# APR1400 Design Certification Review I&C Topics

**KEPCO/KHNP**  
**August 12-13, 2015**

## Q3 Voting Logic (1/5)

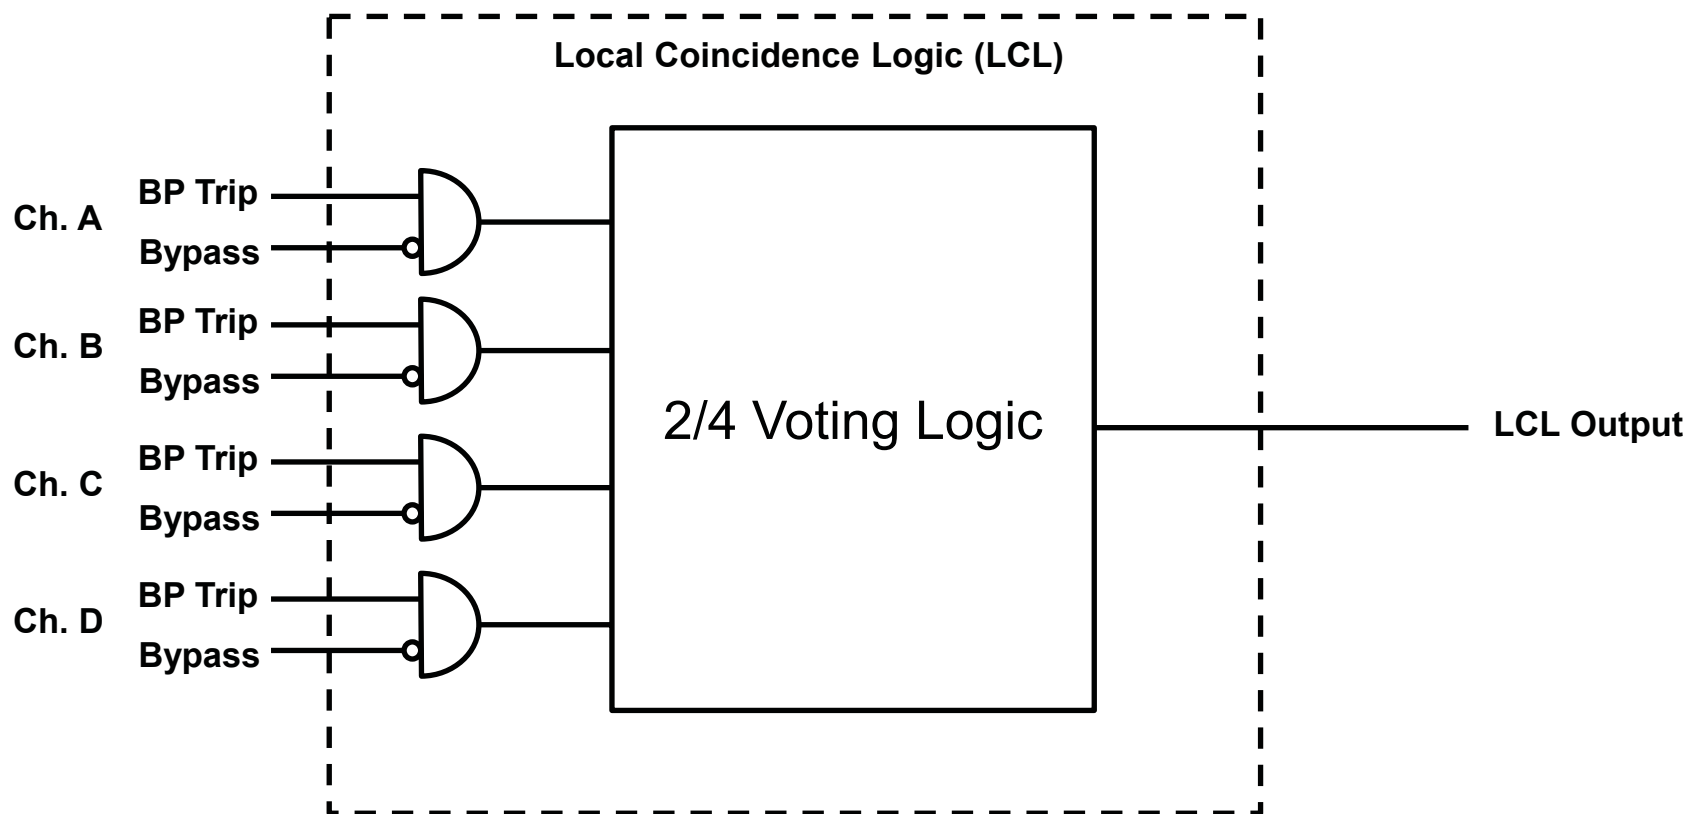
*How are changes made to voting logic when one division fails and another one is in bypass mode?*

- Normal Operation: 4 channel redundancy (2-out-of-4 voting)
- 1 Channel Bypass: 3 channel redundancy (2-out-of-3 voting)
  - The bypassed channel is excluded from the voting logic as shown in the simplified diagram on the next slide.
- 1 Channel Bypass & 1 Channel Single Failure: 2 channel redundancy
  - Failure to trip : 1-out-of-2
  - Failure to untrip : 2-out-of-2

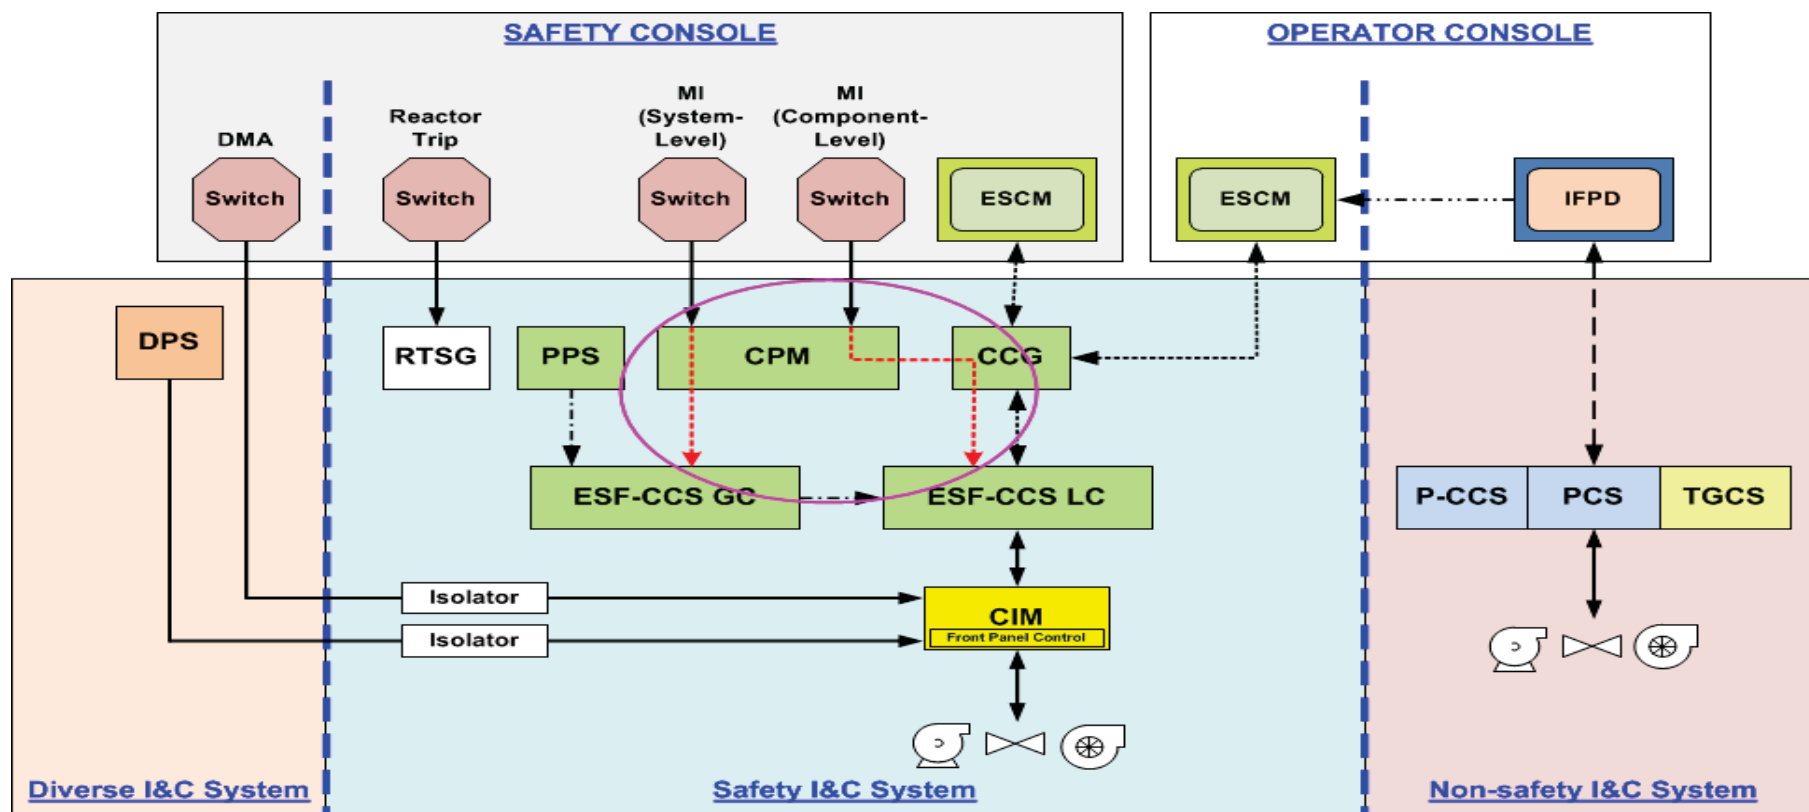
*Figure 7.3-1 in DCD Tier 2, Section 7.3 shows that both MI system-level and component level manual switches only. Figure 4-28 in the Safety I&C System Tech. Report also shows the MI switches only. Figure 7.1-1 in DCD Tier 2 shows both MI switches and ESF switches. Figure 4-13 in the Safety I&C System Tech. Report shows the MI switches, ESF switches, and local manual ESF switches. Clarify the differences among the figures for the same ESF control system and also what safety functions those manual switches will execute?*

- **Response to NRC Question**
  - **Local manual ESF switches are system-level ESFAS switches which are located in the MTP cabinet in the I&C equipment room.**
  - **System-level MI switches and local manual ESF switches are provided for the same purpose to initiate system-level ESFAS actuation.**

DCD Tier 2 Fig. 7.3-3

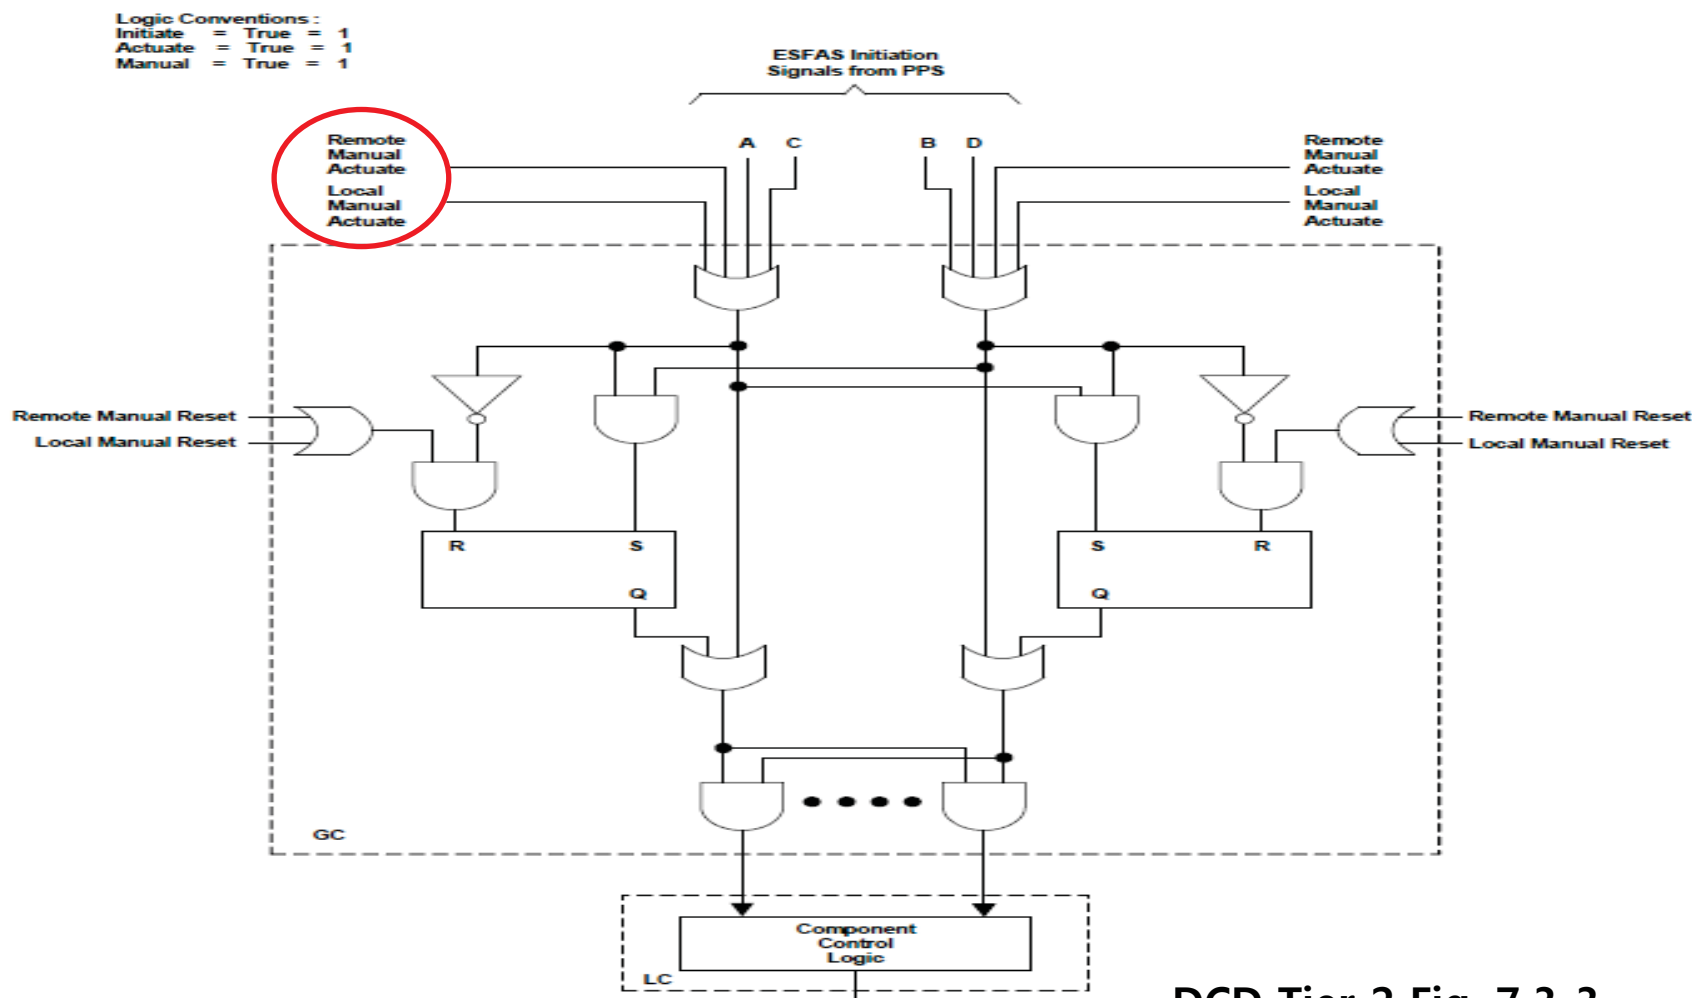
*Because both MI system-level and component level manual switches are connected in the same way to the control panel multiplexer (CPM) as shown in Figure 7.3-1 in DCD Tier 2, Section 7.3, what are the logic differences between these two types of manual control commands in the ESF-CCS system?*

#### – System-level switch signal

- The signal is inputted to the GC via the CPM, and acquired as the input of 2-o-o-4 voting logic in the GC.

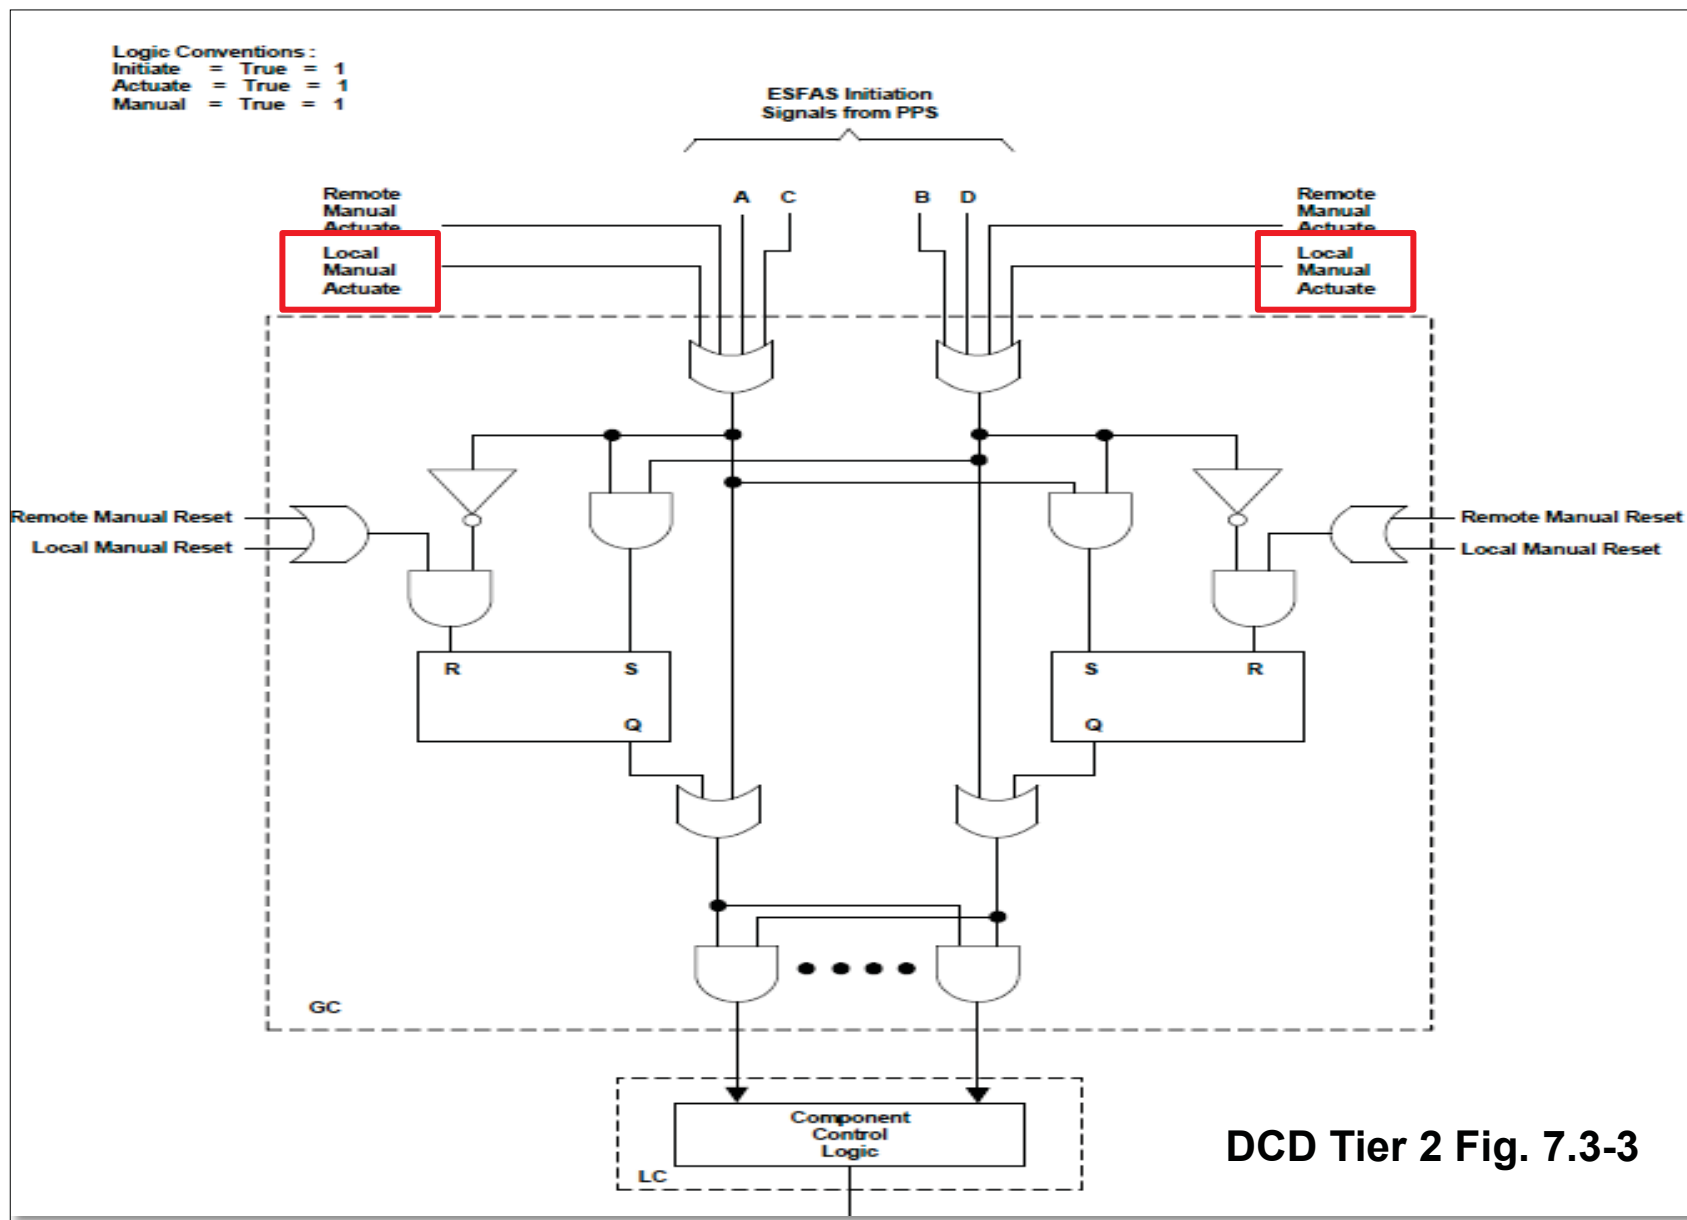
*Besides the remote manual actuation commands, what are the local manual actuation commands at the system level as shown in Fig. 7.3-3?*

- The local manual actuate commands can be initiated from the switch panel of the MTP in the I&C equipment room.
- While the remote manual actuate commands are transmitted to all ESF-CCS divisions, the local manual actuate commands are transmitted only to the corresponding ESF-CCS division.
- The local manual actuate commands exist to test and verify that the components of one ESF-CCS division can be actuated at a time.
